Synapse
Energy Economics, Inc.

**Comments on Consumers
Energy's *Electric Generation
Alternatives Analysis* for the
Balanced Energy Initiative
including the Proposed Karn-
Weadock Coal Plant**

July 7, 2009

Figure Synapse-1: Supply Diversity of Proposed BEI Resource Additions by MWhs

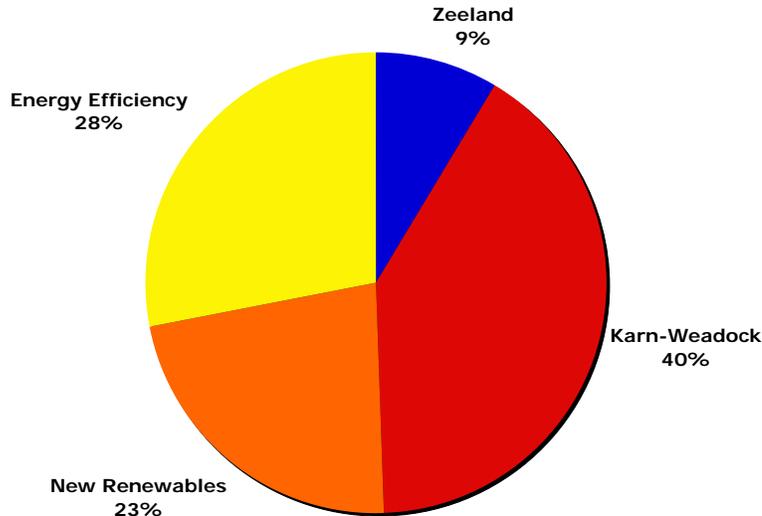
Unfortunately, this figure is based on the MWs of capacity that would be provided by each of the four alternatives presented: Gas Combined Cycle, Renewables, Clean Coal, and Energy Efficiency and Demand Management. However, when considering a company's generation mix, the appropriate way to evaluate the fuel or supply diversity of its facilities is to look at the MWhs of energy provided by each addition or resource type, not the MWs of capacity provided by the resource. This is because the issue of supply diversity is a matter of the amount of fuel that the company burns, and the cost consequences of burning that fuel. Simply looking at its capacity mix, in terms of MWs, does not offer any information about the utilization of that capacity.

If Figure 1 had reflected the MWhs of each of the four alternatives that Consumers Energy says are being added as part of the BEI, the contribution from the proposed Karn-Weadock plant would have been much higher than the 18 percent shown in the pie chart for the "Clean Coal" facility. This can be seen from Figure Synapse-1 below, which presents the MWh of new generation that

Thus, based on the annual energy numbers presented by Consumers Energy, that we have been unable to verify, the Karn-Weadock coal plant will generate forty percent of the total energy that would be provided in 2018 by the new additions through the BEI.³² This is more than double the 18 percent contribution that Consumers Energy claims in the EGAA.

Figure Synapse-2: Consumers Energy’s 2018 Resource Mix by MWs, No Coal Plant Retirements

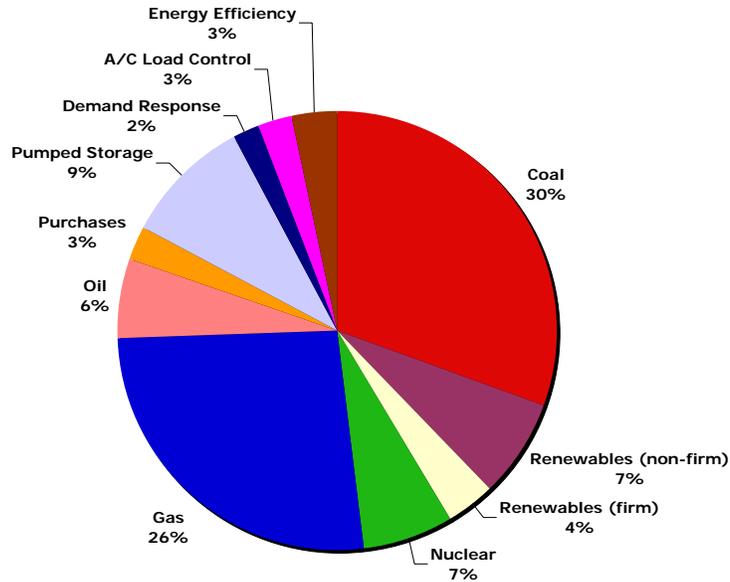
In Figure 8 of the EGAA, Consumers Energy presents its Projected Resource Mix for 2018. However, as with Figure 1 in the EGAA, the information in this mix is based on the MWs of each supply and demand side alternative, and not on the MWhs. Thus, the information overstates the contributions from renewable resources and the demand side alternatives and understates the contribution from fossil alternatives. Unfortunately, Consumers Energy does not provide the annual energy emissions from its individual units or by fuel type, so we are unable to prepare a substitute for Figure 8 in the EGAA that shows what the Company's proposed resource mix would be based on the MWhs generated by each fuel and resource type. However, it is clear that the contribution from coal-fired plants will be significantly higher than the 24 percent shown in Figure 8 of the EGAA.

Moreover, Figure 8 of the EGAA also misrepresents Consumers Energy’s likely Capacity Fuel Mix in 2018, even if you consider MWs not MWhs, because it reflects the retirement of 950 MW of existing coal capacity as well as the addition of the alternatives included in the Company’s BEI.

Figure Synapse-2 below, presents what the Company’s resource mix would be in 2018, by MWs of capacity, if it adds the proposed BEI resources but does not retire any of the 950 MW of existing coal capacity that it suggests, but does not commit to, retiring.³³

Thus, even if just the MWs of capacity are considered, coal will represent 30 percent of Consumers Energy’s fuel mix in 2018, and fossil-fired capacity will represent more than 60 percent of its fuel mix. Again, the coal clearly would represent a significantly higher percentage of the Company’s fuel mix in 2018, and subsequent years, if information on the MWhs of generation by fuel type were available.

Figure Synapse-6. CO₂ prices used by Synapse and Consumers Energy vs. results of modeling analyses of major bills in the U.S. Congress – levelized CO₂ prices (2013-2030, in 2007 dollars).

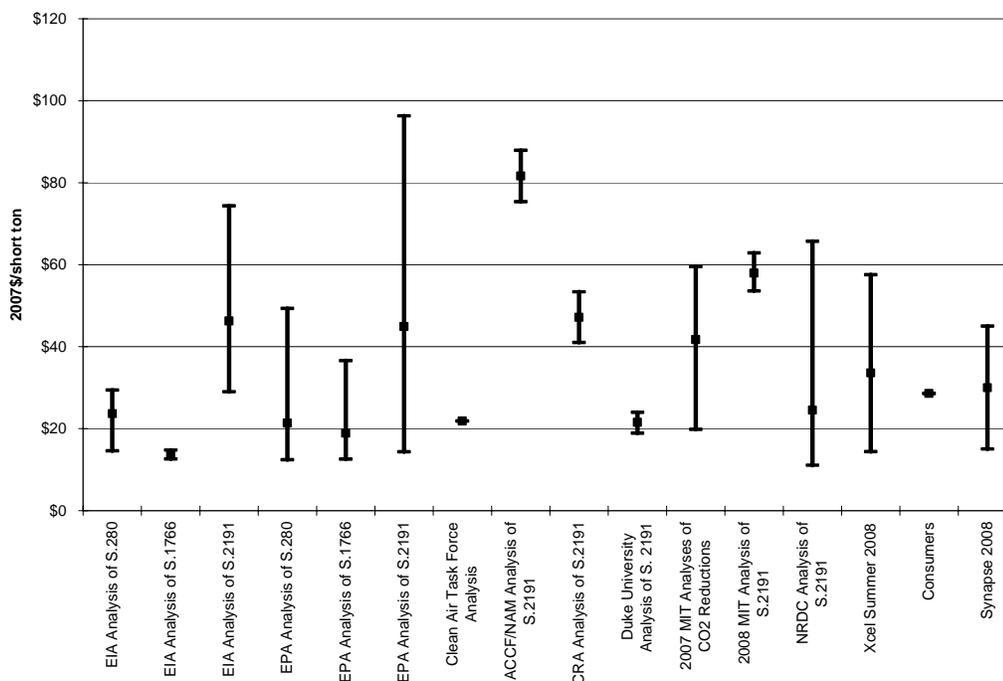
Figure Synapse-6, below, compares the levelized CO₂ cost used by Consumers Energy and the range of CO₂ prices that Synapse recommends be used for resource planning with the results of the modeling analyses of the major climate change bills that have been proposed in the U.S. Congress. As can be seen, the CO₂ prices recommended by Synapse are very reasonable compared to the range of CO₂ emissions allowance prices that could have resulted from adoption of the major greenhouse gas regulatory legislation that has been considered in the U.S. Congress. In fact, under many possible scenarios, CO₂ allowance prices could substantially exceed the high ends of the price range that Synapse recommends for use in resource planning assessments.

In fact, there are a significant number of possible scenarios where CO₂ emissions allowance prices could be substantially higher than the high ends of the CO₂ price that Consumers Energy used in the EGAA.

Consumers Energy also presented levelized costs for the coal and natural resource options that assumed it would not have to pay for emissions allowances, that is, that the price of allowances was \$0/ton. The failure to include any price for CO₂ heavily biased the results of these scenarios in favor of the proposed Karn-Weadock Plant, the coal alternative. The assumption that Consumers Energy would not have to pay any CO₂ prices at any time in the expected 60 year operating lives of the new coal plant that would come on-line in 2017 relies on one or both of two flawed assumptions: either that there will be no federal regulation of greenhouse gas at any point in the expected 40 to 60 year operating lives of new coal plants like the new Karn-Weadock unit or that Consumers Energy will receive free allowances for all of the CO₂ emissions from the new plants. Both of these assumptions are unrealistic in the face of the recently announced Administration cap-and-trade plan and legislative trends in the U.S. Congress. For this reason, any cost comparison that does not include CO₂ costs has no probative value and should not be given any weight.

Figure Synapse-8. Consumers Energy vs. Recent AEO Natural Gas Price Forecasts

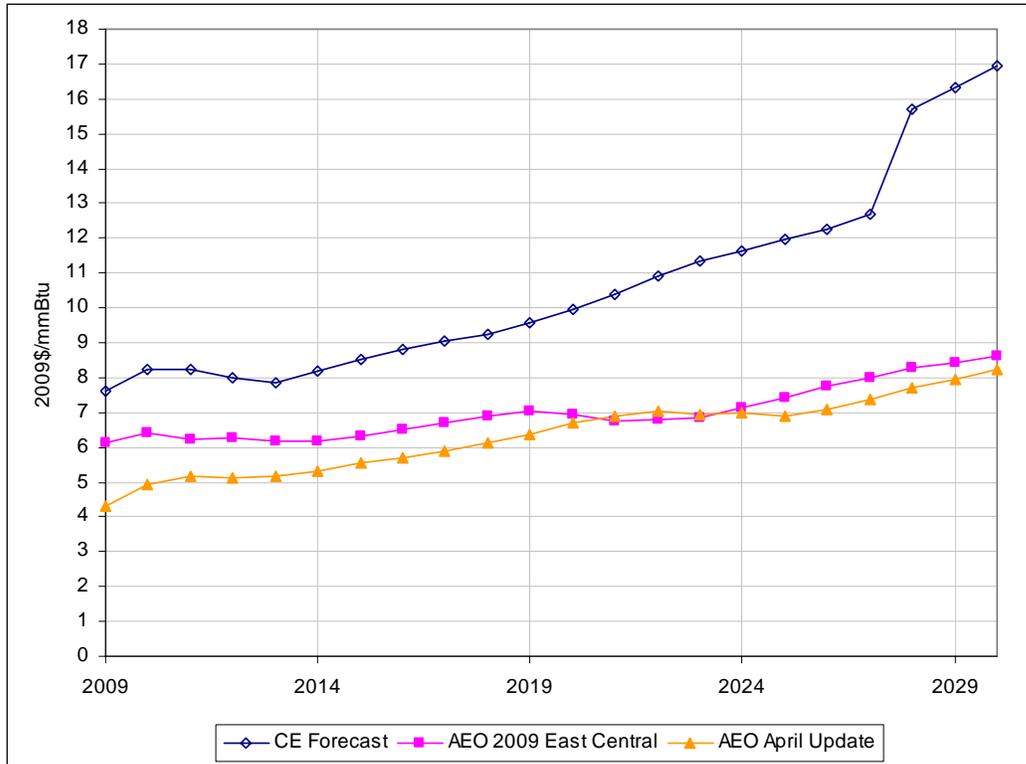
For example, Figure Synapse-8 below compares the natural gas prices used by Consumers Energy in the levelized cost analyses in the EGAA with the AEO's March 2009 forecast for the East Central Region, that includes Michigan, and with the AEO's April 2009 revision that reduced forecast natural gas prices even further. As can be seen, the Consumers Energy forecast gas prices are much higher than the projected AEO prices in every year.
